# - uBITX - rx-tx-pop fix

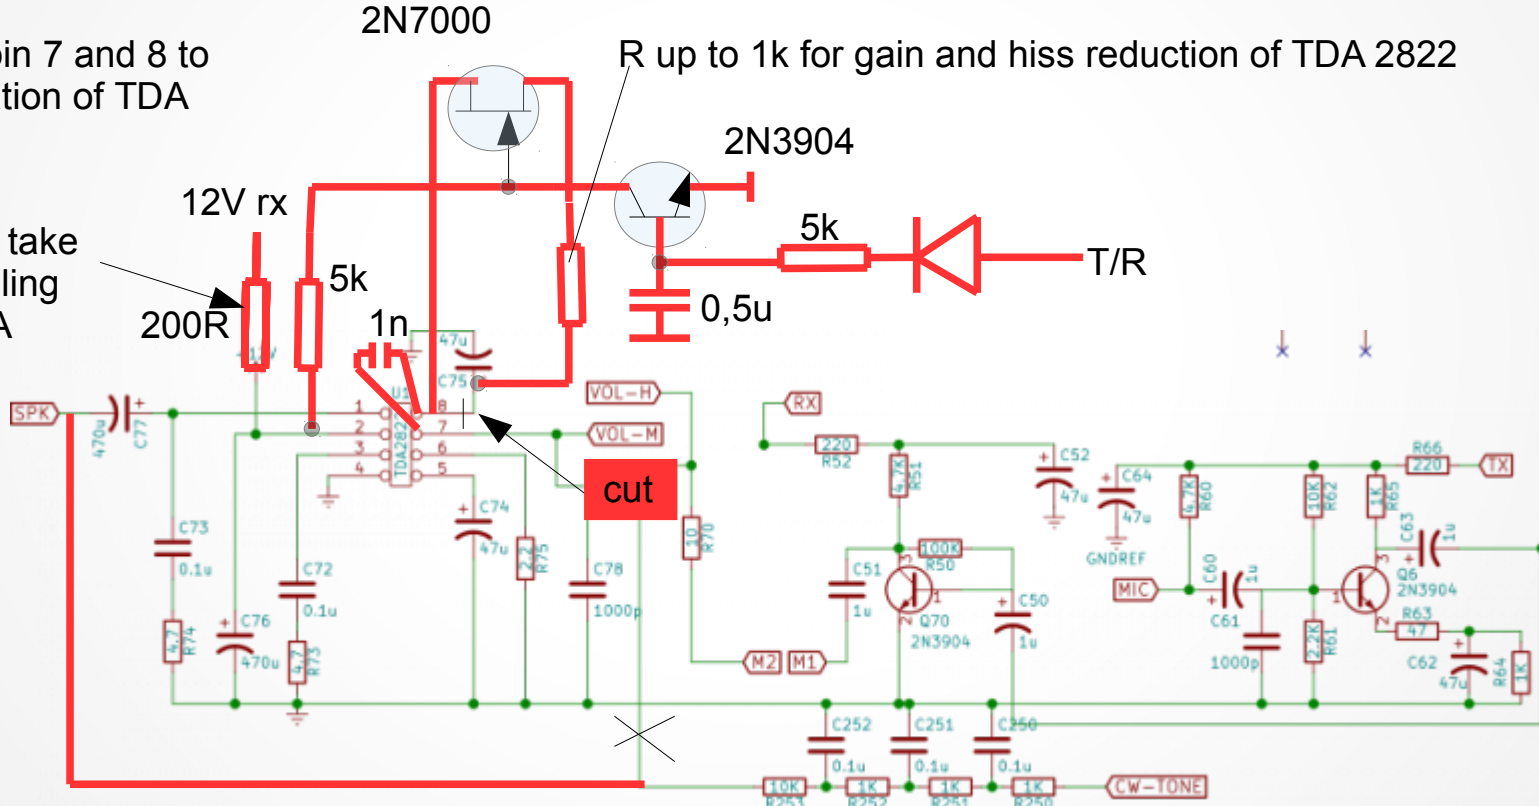
1nF between pin 7 and 8 to  
block RF-oscillation of TDA

200R and 470u take  
care for decoupling  
12v rx from TDA

R up to 1k for gain and hiss reduction of TDA 2822

connect too loud sidetone directly to SPK – as TDA is now  
without voltage during tx
